# Access Compliance Report

## Public Rights-of-Way

Intersection ID: 12355	Main Street: MONUMENT_ST	Cross Street: GREENLAND_AV	Location: SW
ADA ID: 745434270200	Ramp Type: Perp	Initial Pass/Fail: Fail	Overall Compliance: No
Codes/Mitigation Info/Possible Solution		Field Measurements/Component Compliance	
Severity Score: 10

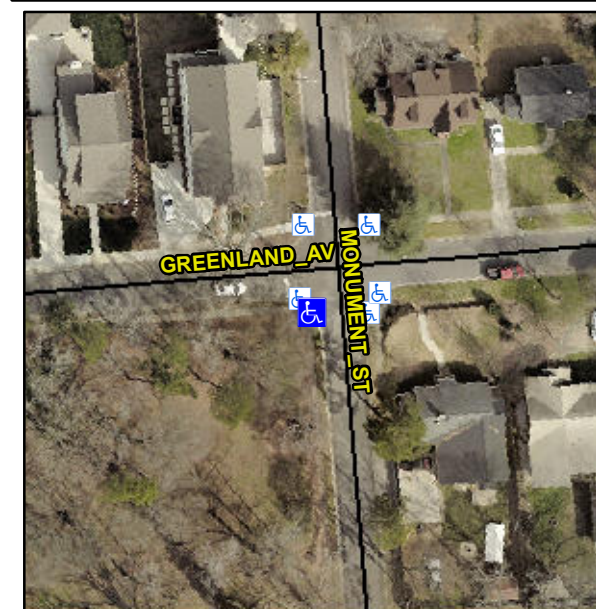
**Not Found, R304.5.1, R304.5.3**

Compliance	Description	Data	Compliance	Description	Data
N/A	Ramp Length (in)	93.0	Yes	Ramp Slope (%)	5.1
No	Ramp Width (in)	46.5	No	Ramp XSlope (%)	2.1
N/A	Flare Type LT	N/A	N/A	Flare Type RT	N/A
N/A	Flare Slope LT (%)	N/A	N/A	Flare Slope RT (%)	N/A
N/A	Flare Traversable LT?	N/A	N/A	Flare Traversable RT?	N/A
N/A	Landing Length (in)	N/A	N/A	DWS Provided?	N/A
N/A	Landing Width (in)	N/A	N/A	DWS Contrast?	N/A
N/A	Landing Slope (%)	N/A	N/A	DWS Length (in)	N/A
N/A	Landing X Slope (%)	N/A	N/A	DWS Full Width?	N/A
N/A	Landing Curb? (Y/N)	N/A	N/A	DWS Offset (in)	N/A
N/A	Shared Landing?	N/A			
N/A	Gutter Ponding?	N/A	N/A	Gutter Slope (%)	N/A
N/A	Gutter Lip Ht (in)	N/A	N/A	Gutter X Slope (%)	N/A
N/A	Painted X Walk1?	No	N/A	Painted X Walk2?	N/A
	X Walk 1 Direction	To E		X Walk 2 Direction	N/A
N/A	X Walk 1 Width (in)	N/A	N/A	X Walk 2 Width (in)	N/A
	X Walk 1 Slope (%)	0.0		X Walk 2 Slope (%)	N/A
	X Walk 1 X Slope (%)	4.0		X Walk 2 X Slope (%)	N/A

**Remove & Replace Entire Ramp.**
